UNITED STATES PATENT AND TRADEMARK OFFICE

10/598,316

Office Action Summary	Application No. 10/598,316	Applicant(s) USOWICZ ET AL.	
	Examiner MATTHEW W. JELLET	Art Unit 3753

DETAILED ACTION

10. *Nichols* anticipates the device and in the alternative provides a device capable of performing the method steps of controlling flow of fluid, as can be seen in Figs. 1 and 2 below:

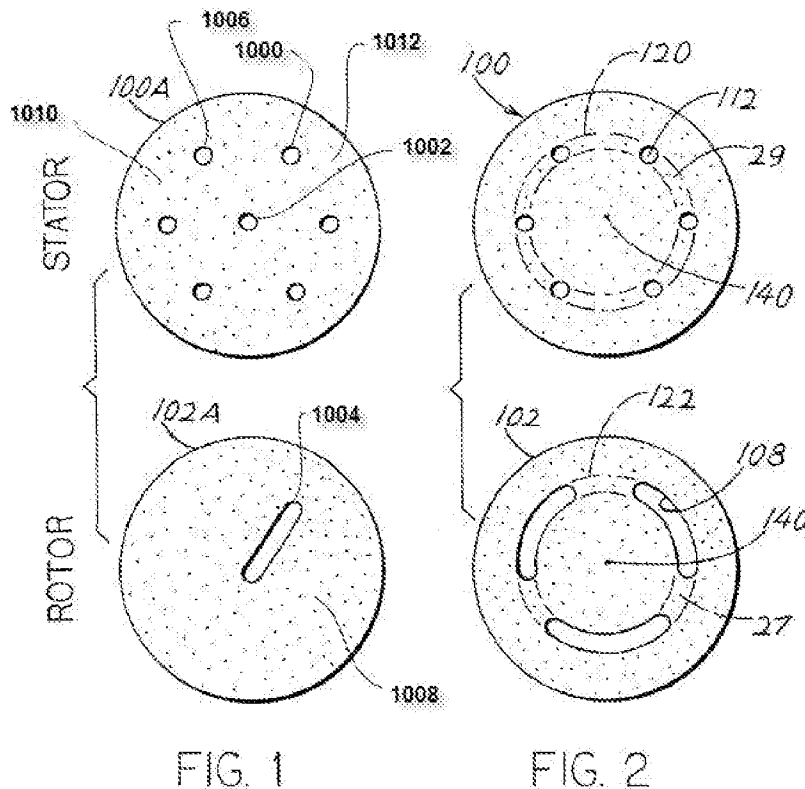
A device for controlling the flow of fluid comprising (Fig. 1): a rotor (102A) having a rotor fluid communication means (1004 Fig. 1) and at least one rotor load bearing surface (1008) which rotor load bearing surface sealably engages a stationary load bearing surface (Col 5 lines 45 – 50), said rotor capable of assuming a first position and a second position by rotation (Col 1 lines 16 – 25 where the rotor rotates to select the passages on the stator); at least one stator (100A Fig. 1) having a stationary load bearing surface (1010 Fig. 1) having stator fluid communication means (passages located on the stator Fig. 1), said stationary load bearing surface sealably

engaging said rotor load bearing surface and permitting rotation of said rotor with respect to said stator (Col 5 lines 45 – 50), wherein in said first position said rotor fluid communication means and said stator fluid communication means prevent the flow of fluid (1004 may be aligned with position 1012 and stator opening 1002 to prevent the flow of fluid Fig. 1) and in said second position said rotor fluid communication and stator fluid communication means permits the flow of fluid (1004 may be aligned with stator communication means 1000 and 1002 to allow the flow of fluid between 1000 and 1002); at least one of said rotor bearing surface and said stator load bearing surface having a diamond like carbon coating (162 Fig. 7, tungsten carbide/carbon is a form of diamond like carbon); compression means for holding said at least one stator and rotor with said in rotor load bearing surface and stationary load bearing surface sealably engaged (the device requires a clamping means to exceed the high pressure, for example 5000 psi (see Col 1 lines 65-67, Col 2 lines 23 – 35), it is well known in the art to use a housing or other clamping means to hold the rotor and stator together under high levels of pressure. The express, implicit, and inherent disclosures of a prior art reference may be relied upon in the rejection of claims under 35 U.S.C. 102 or 103. “The inherent teaching of a prior art reference, a question of fact, arises both in the context of anticipation and obviousness.” In re Napier, 55 F.3d 610, 613, 34 USPQ2d 1782, 1784 (Fed. Cir. 1995) (affirmed a 35 U.S.C. 103 rejection based in part on inherent disclosure in one of the references). See also In re Grasselli, 713 F.2d 731, 739, 218 USPQ 769, 775 (Fed. Cir. 1983). *Nichols* clearly anticipates the clamping means because *Nichols* must have a means such as a housing to hold the rotor and stator together under high levels of compressive forces (i.e. 5000 psi or greater)), and said diamond carbon coating providing a low friction and increased hardness allowing repeated movement between said first

and second positions (Col 1 lines 45-50). *Nichols* does not disclose or teach a diamond like carbon coating with silicon (silica). *Welty* (US 6904935) does teach the use of a diamond carbon type silica coating (See Col 4 lines 40 – 40), where the use of a ceramic such as silicon carbide can be the base material, or where use of silicon can be used as an adhesion promoting layer. It would have been obvious to one of ordinary skill at the time of the invention to modify the device utilizing the diamond like carbon layer of *Nichols* as the bearing layer, and to bind the bearing layer to the base layer utilizing the silicon materials as provided in *Welty*, so that as discussed in *Welty*, the bearing layer adhesion to the substrate of for example the stator may be improved.

12. **In regards to Claims 3 and 14** *Nichols* anticipates: The device of claim 1 wherein said stator fluid communication means is at least one stator opening (1000 Fig. 1) in said stator, said at least one stator opening for being place in fluid communication with a conduit (1004 Fig. 1, acts as a conduit to convey fluid between 1000 and 1002 when arranged to connect the two openings).

13. **In regards to Claims 4 and 15** *Nichols* anticipates: The device of claim 1 wherein said rotor fluid communication means comprises at least one opening (1004 acts as an opening to channel fluid from 1002 to for example 1006 or vice versa).

14. **In regards to Claims 5 and 16** *Nichols* anticipates: The device of claim 3 wherein said rotor fluid communication means comprises a channel for placing two or more stator openings in fluid communication (1004 Fig. 1).

16. **In regards to Claim 23**, as far as it is definite, *Nichols* further anticipates: [the device] with more than 2 positions (See Fig 1 where 1004 can be rotated to meet additional openings on the stator).
